Black Oak Ranch Water Conservation Project

Salmonid Restoration Federation

REQUEST FOR BIDS ADDENDUM

Issued March 19, 2025

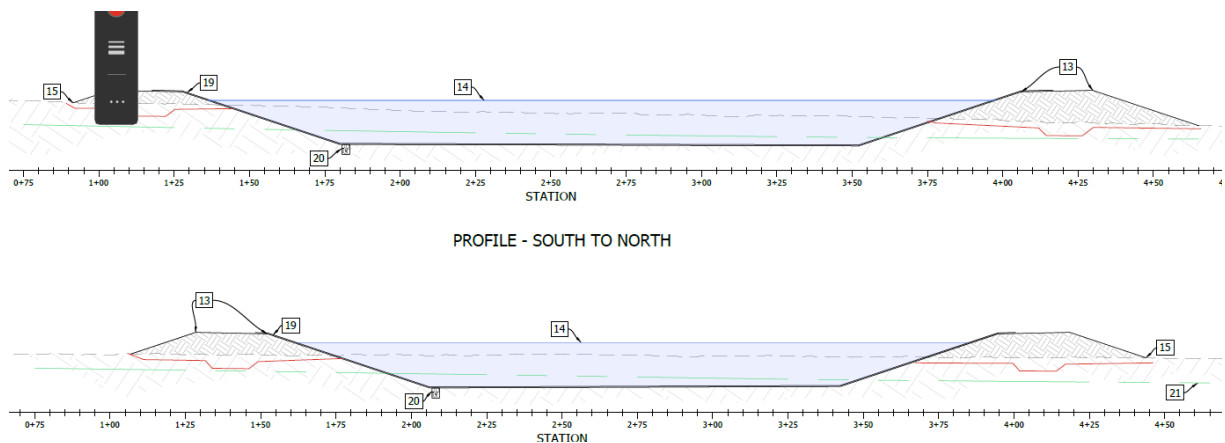
3) Tank pad preparation

It is anticipated that an area of ground approximately 150 ft x 150 ft will be prepared for tank installation. Contractor should anticipate the following steps:

- 1) Remove upper 2 ft of soil. Place soil to the west within the 3-acre conversion avoiding existing hardwoods and feather into existing grade.

- 2) Excavate additional ~250 CY wedge of competent soil from eastern half of pad to create final tank pad grade.
- 3) Over-excavate an additional ~250 CY wedge of competent soil from western half of pad and re-compact ~500 CY of engineered fill to create western half of tank pad.

Subgrades shall be inspected by engineer before engineered fill is placed and final pad elevations are finalized. See attached Bid Package Addendum Sheet 2 of 2.
